COUNCIL ASSESSMENT REPORT

Panel Reference	2017HCC002
DA Number	DA/11/2017
LGA	Lake Macquarie City Council
Proposed Development	Demolition Works, Commercial Premises and Residential Flat Building
Street Address	5 Edgar Street, Belmont (Lot 10 Sec B DP 585) 7 Edgar Street, Belmont (Lot 11 Sec B DP 585) 9 Edgar Street, Belmont (Lot A DP 400644) 11 Edgar Street, Belmont (Lot B DP 400644) 2 Sharp Street, Belmont (Lot 6 DP 12898) 4 Sharp Street, Belmont (Lot 5 DP 12898) 6 Sharp Street, Belmont (Lot 4 DP 12898) 8 Sharp Street, Belmont (Lot 1 DP 353066) 10 Sharp Street, Belmont (Lot 2 DP 353066) 32 Brooks Parade, Belmont (Lot 3 Sec B DP 585) 36 Brooks Parade, Belmont (Lot 4 Sec B DP 585) 38 Brooks Parade, Belmont (Lot A DP 339105) 40 Brooks Parade, Belmont (Lot B DP 339105) 42 Brooks Parade, Belmont (Lot 8 DP 12898) 44 Brooks Parade, Belmont (Lot 7 DP 12898)
Applicant	Monteath and Powys Pty Ltd
Owner	Allbeach Pty Limited AM, KL and MF Brown BSE Holdings Pty Limited Lakesharp Developments Pty Limited Robert Neil McDonald MD & JE Hughes

Report prepared by	Brian Gibson, Senior Development Planner, Lake Macquarie City Council
Report date	4 October 2018

Figure 7A: Proposed building heights in relation to 22m Building Height Limit under the LMLEP2014 for Blocks A and B

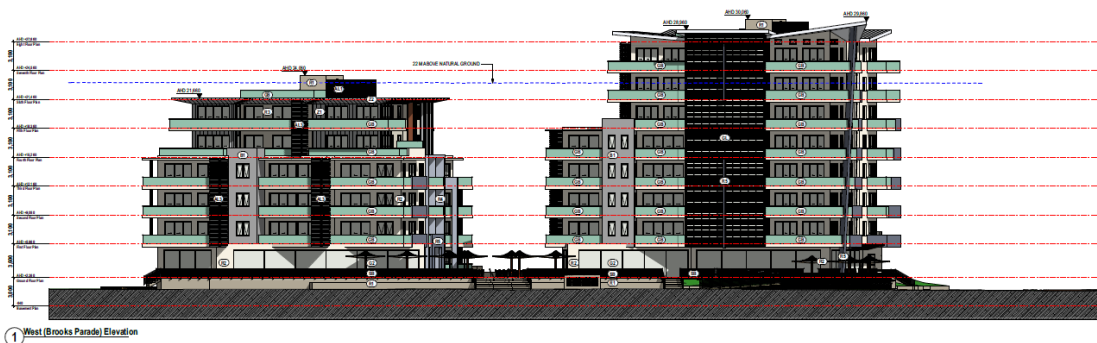
The exceedance of the maximum height of building is not supported, refer to assessment comment under section 2 of the report.

1. Building	2. Location of exceedance	3. Variation (m)	4. Variation (%)
5. Block A	6. 27.95m (eight storeys) excepting the roof feature which measures 29m and the plant and lift overrun measuring 29.2m	7. 7.2m	8. 32.7%
9. Block B	10. 20.65m (six storeys) excepting the lift overrun which is 23.2m	11. 1.2m	12. 5.45%
13. Block C	14. 21.4m (six storeys) excepting the lift overrun which is 23m	15. 1m	16. 4.5%
17. Block D	18. 21.1m (six storeys) excepting the plant and lift overrun which is 23.1m	19. 1.1m	20. 5%

Figure 17: Excerpt from Belmont Centre Structure Plan

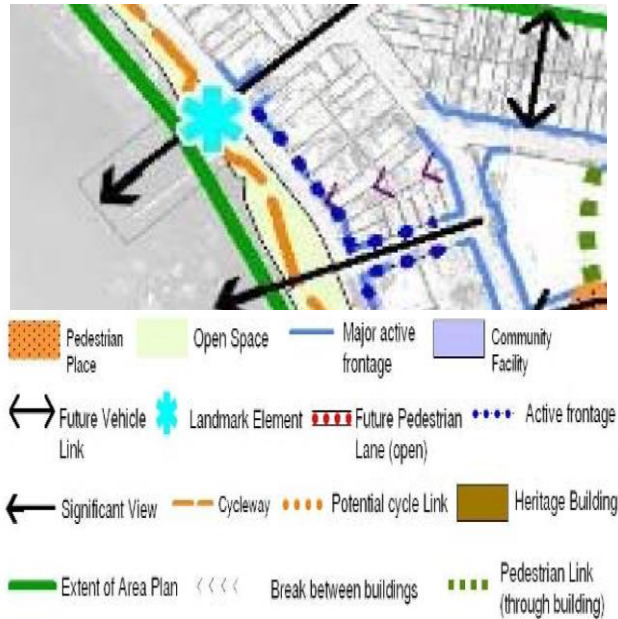
The provisions of clause 7.10(6) is 'all or part of the ground floor of the building facing the primary street has an active street frontage'. Having regard to the Belmont Town Centre Structure Plan (Figure 17) Edgar Street is identified as a major active frontage, with Sharp Street and Brooks Parade as active frontages.

Figure 18: Excerpt from Belmont Centre Structure Plan

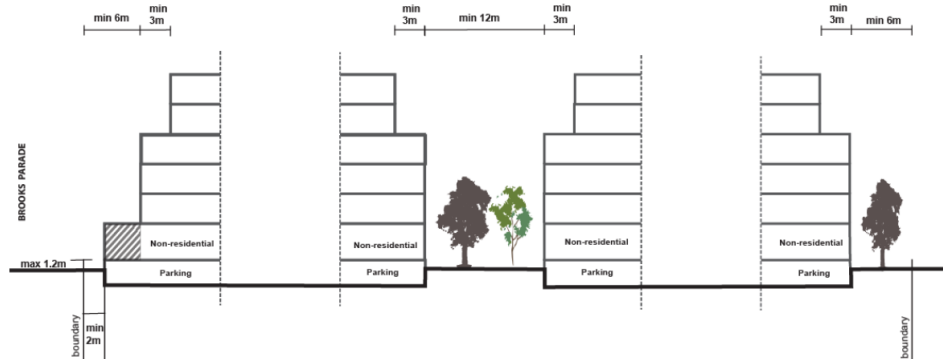
The development proposes four towers above a podium, three of which are six storeys and the fourth being eight storeys. Each of these towers exceed the permitted maximum height.
